SERVICE LETTER 261

WIRE TERMINAL BLOCK REPLACEMENT

Aircraft Makes/Model(s):	Float Model(s):	Compliance: Optional	By: MAS
Textron Aviation 208, 208B,	Textron Aviation 208, 208B, Air Tractor AT-802 & AT-802A, DeHavilland DHC-6 8750A, 10000A, & 13000A	Part Number: 1012490	Approved: DRH
1		Date: 4/3/2025	Revision: C

8750A Float Model

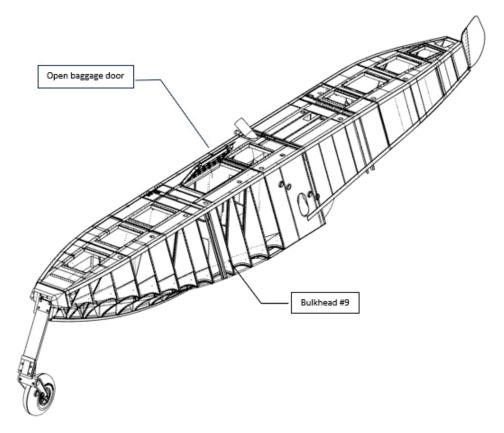
- 1. Position and prepare aircraft for safe maintenance.
- 2. Disconnect aircraft battery.
- 3. Locate the existing wiring terminal. For 8750, the terminal is in the aft baggage compartment on bulkhead #9. For 10,000 series, the terminal is on the forward bulkhead in the baggage compartment, bulkhead #9. The terminal block on the 13000 series float is in the front baggage compartment on bulkhead #6.

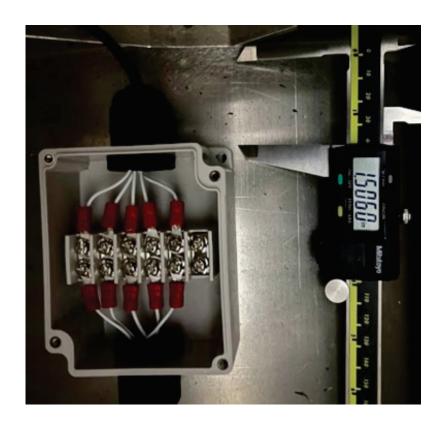
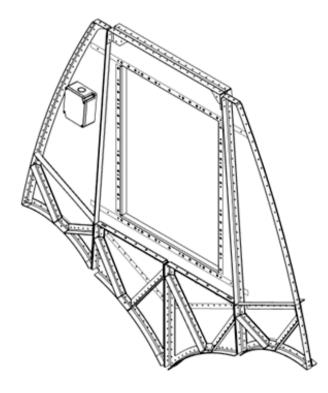
5. Remove the wires from the existing terminal block and remove the existing terminal block.

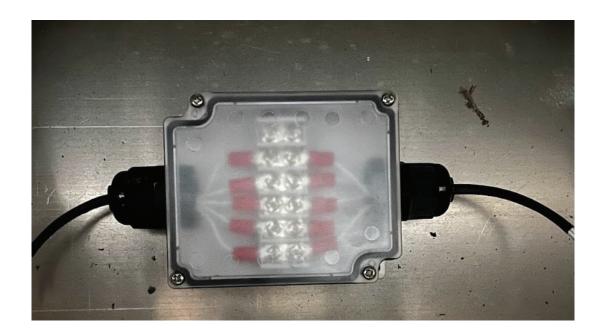
14. Secure each wire pairing to the new terminal block in the housing. Place CorrosionX or equivalent compound on the terminal junctions.
